Access Compliance Report Public Rights-of-Way (Curb Ramps)

Main Street: KERTH_DR		Cross Street: DONOVAN_RD		Location:	E
ADA ID: RPRK211217113115	Ramp Type:Type 1 - Perpendicular	Initial Pass/Fail: Pass	Overall Compliance: No	Severity Score:	26

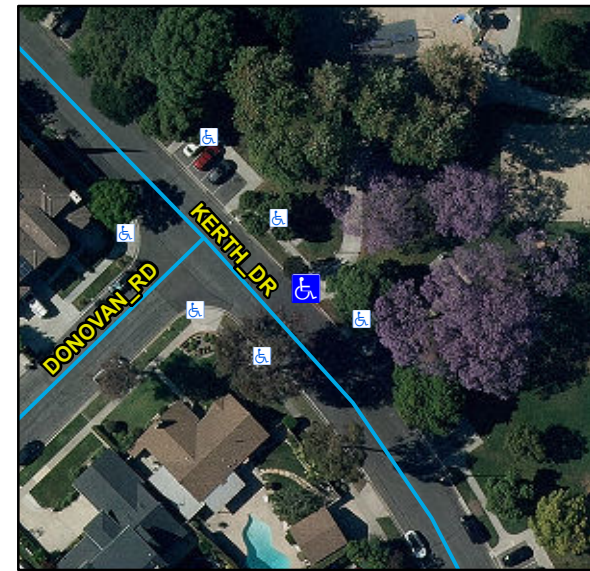
Install Detectable Warning System. Remove & Replace Gutter.
